## **Objection to proposed Metal Recovery and Recycling Facility (SSD 8375) 56-69 Tattersall Road, Kings Park**

This letter is our formal objection to the State Significant Development (SSD) Application for the metal recovery and recycling facility (SSD 8375) (the Proposal) at the 'Pick and Payless' site, 56-69 Tattersall Road, Kings Park (the P&P site). This letter has been prepared based upon our review of the documentation (Environmental Impact Statement (EIS) and associated technical reporting and plans) placed on public exhibition for SSD 8375.

Figure 2 Potential further impacts to trees (vegetation) not assessed within the EIS (amended from Figure 5 of the EIS)

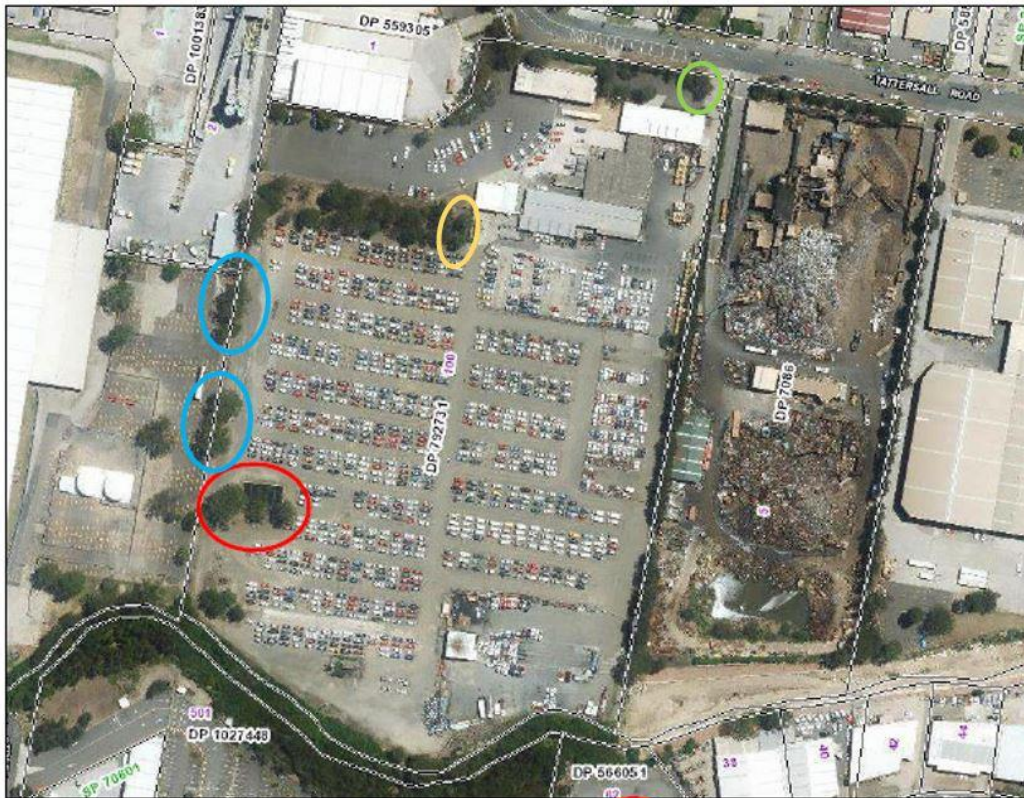
<p>Section 4.4.2 of the EIS indicates that one tree adjacent to the western property boundary would be removed. No other trees are indicated to be removed. Notwithstanding this, based on the Development Plan (Appendix A of the EIS) and knowledge of existing vegetation it seems likely that other trees would be removed or impacted by the Proposal, namely:</p> <ul style="list-style-type: none"> <li>• Extension to the width of the eastern driveway – impact or removal of trees on the northern (street frontage) of the P&amp;P site</li> <li>• Construction of a western driveway (from the existing visitor car park) – removal of trees on the landscaped mound – it is understood that these trees have been unlawfully removed (refer to Section 4 of this submission).</li> <li>• Establishment of the roadway along the western boundary – removal of trees or damage to root structures.</li> </ul> <p><i>Attachment A</i> of this submission shows an outline of the trees anticipated to be impacted by the Proposal, which have not been considered within the EIS. <i>Attachment B</i> of this submission show trees which have been recently removed (which may be an unlawful activity).</p>	Section 4.4.2 and Appendix A.	The Development Description should be updated to clarify whether further tree removal/impact is to be undertaken. Further impact assessment should be undertaken accordingly.

*Figure 3 Other sensitive industrial receivers not considered within the air quality impact assessment*

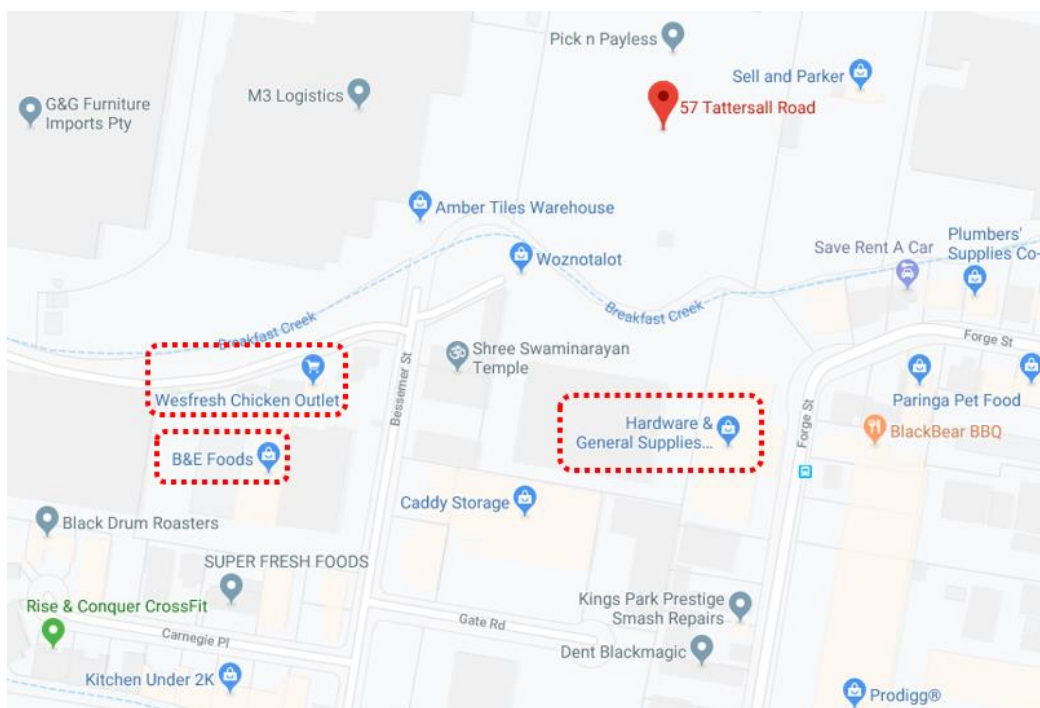
No.	Issue	Comment	EIS Reference	Initial recommendation
8	<b>Air Quality and odour</b>	<p>Section 2.1 of the Air Quality Impact Assessment (Appendix E of the EIS) identifies sensitive receivers that have been considered for the purposes of this impact assessment. The Sell and Parker site, or any surrounding industrial receivers, have not been identified as receivers. It is noted that the Sell and Parker site is an industrial operation, notwithstanding this for the health and safety of employees the air quality impacts (including odour) should be considered for this site.</p> <p>In addition to the Sell and Parker site, the following surrounding sensitive industrial receivers (as shown in <i>Attachment A</i>) have not been considered in the air quality (or odour) impact assessment:</p> <ul style="list-style-type: none"> <li>• Hardware &amp; General Supplies Limited Blacktown - 24/32 Forge St, Blacktown NSW 2148</li> <li>• B&amp;E Foods - 25 Bessemer St, Blacktown NSW 2148</li> <li>• Wesfresh Chicken Outlet - 25 Bessemer St, Blacktown NSW 2148.</li> </ul>	Appendix E	An air quality impact assessment should be provided for potential impacts on the Sell and Parker site and the surrounding industrial area.
